ATTACHMENT I
PROPOSED TECHNICAL SPECIFICATIONS CHANGES
RELATED TO
STEAM GENERATOR TUBE PLUGGING LIMIT

NEW YORK POWER AUTHORITY
INDIAN POINT 3 NUCLEAR POWER PLANT
DOCKET NO. 50-286

SAFETY EVALUATION OF PROPOSED TECHNICAL SPECIFICATIONS
RELATED TO STEAM GENERATOR TUBE PLUGGING LIMIT

INDIAN POINT 3 NUCLEAR POWER PLANT
SAFETY EVALUATION
FOR REVISION TO TECHNICAL SPECIFICATIONS

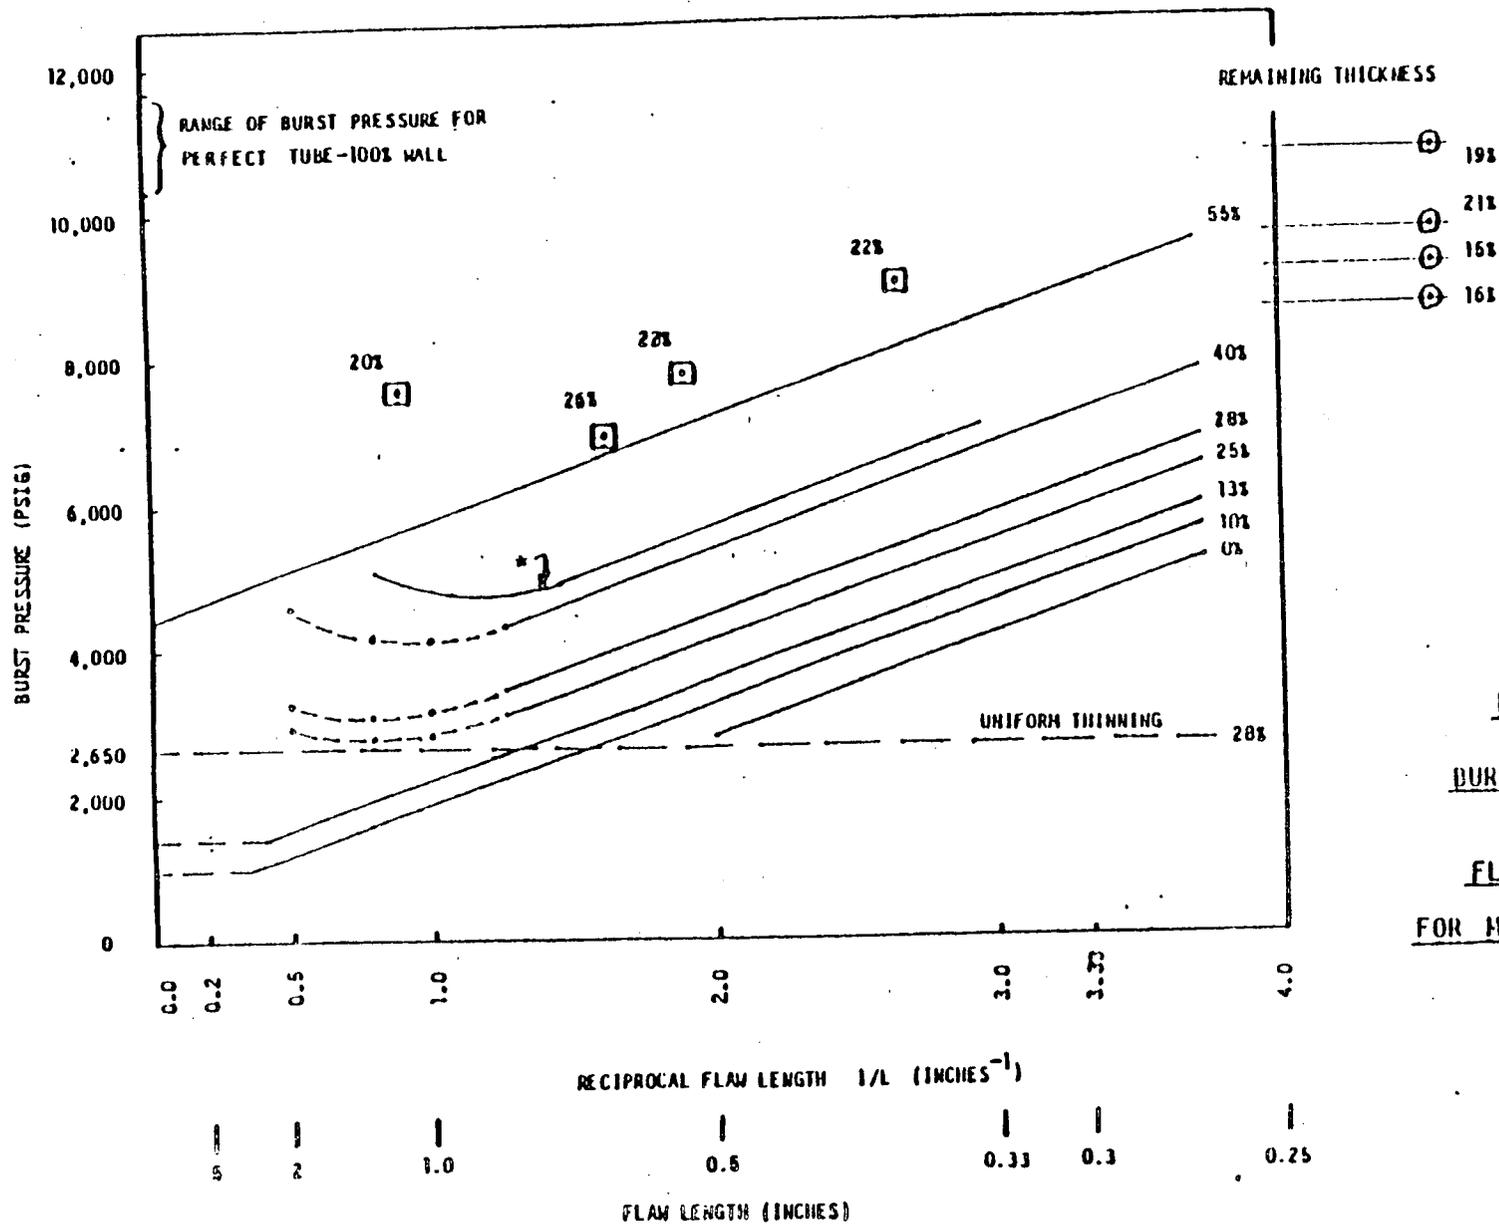
2. Also, during the Authority's September 21, 1982 presentation and subsequently documented in the Authority's letter to the NRC dated October 18, 1982, extensive tube burst test data was presented. The most applicable results are attached as Figure 1 and illustrates the results of tests performed by Westinghouse and documented in the Authority's presentations to the NRC in October 1981 and September 1982.

In Figure 1, the Authority pointed out that 25% remaining wall thickness for all tested flaw lengths (up to 2") is adequate to withstand the maximum ΔP (2650 psi) calculated to occur during faulted conditions. By adding 10% eddy current uncertainty and a 2% corrosion allowance which is conservative

This description correlating the burst test data with the flaw sizes and lengths on the tubes in question incorporates two additional conservatisms. The first is that no credit is assumed for the ligaments between the defects. If this were taken into account, the curve marked by an asterisk in Figure 1 is appropriate which indicates an increase of approximately a factor of 2 in the ΔP needed to cause a burst tube. The second conservatism is that the flaws are assumed to be located in a straight line on the tube such that they can be simulated by a machined flat. In fact it is more likely that these are distinct pits oriented at different positions around the circumference of the tube and do not lie in a straight line. This would greatly improve the tubes ability to withstand high ΔP 's approaching the strength of non-pitted tubes.

FIGURE 2

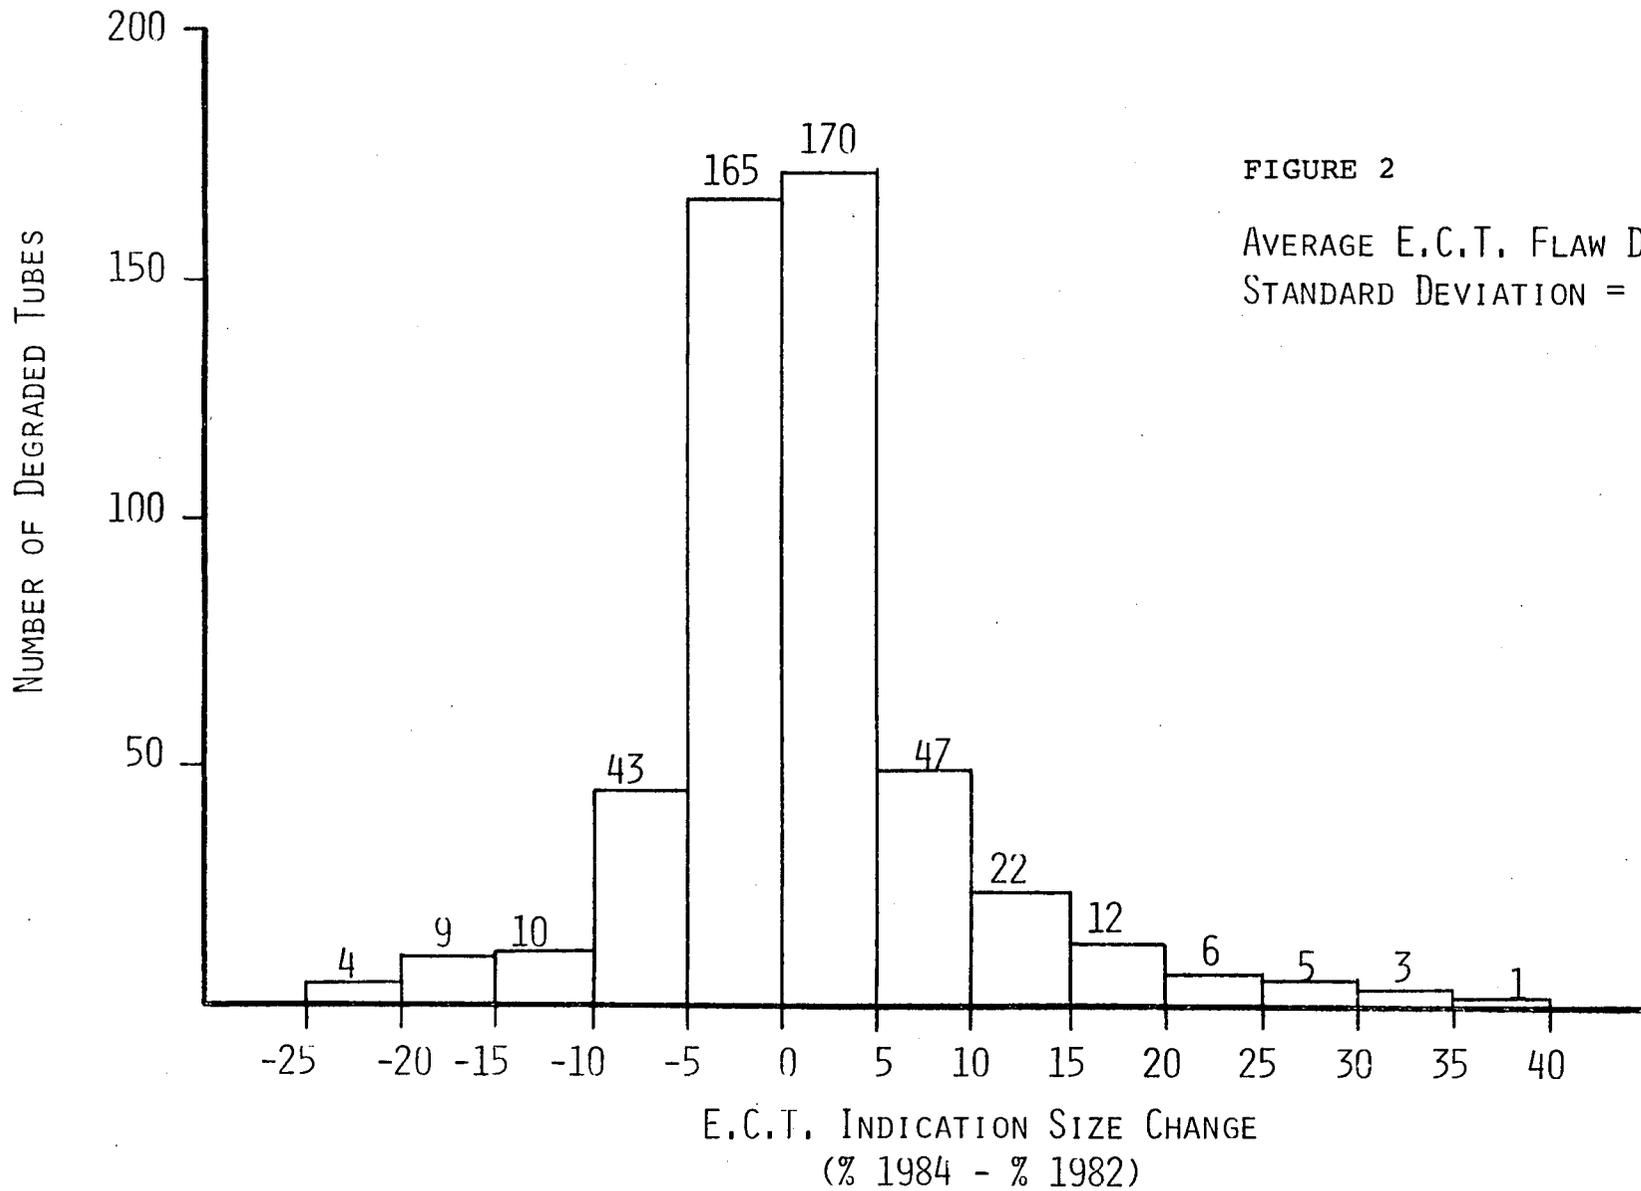
for the remainder of Cycle 4, based on the 1984 midcycle (Cycle 4) outage results for 511 tube cold leg sample of 2 generators. These results indicate an average increase in defect size of less than 2% over a 9 month operating period, as shown in the attached Figure 2. As noted in Figure 2, the actual average flaw growth rate for 9 months is 1.5% with a standard deviation of 9.1%.
